Product Technical Information

Issue No. PTI-JUK076

Title: XA Connector: (4 Circuit Housing for wire to wire) mating part shape change

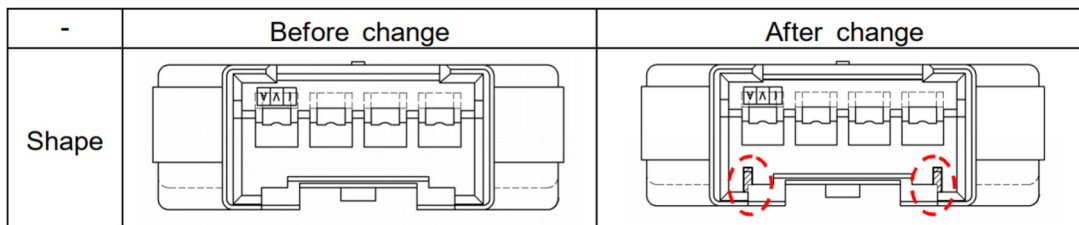
Mating part shape of the XA connector (4 circuit housing for wire-to-wire) shall be changed.

- Inverse insertion prevention key for preventing the inverse insertion shall be added as shown below;
- Suffix (C) shall be added to part number for changed part.

- Product performance: No change
- Appearance: See detail
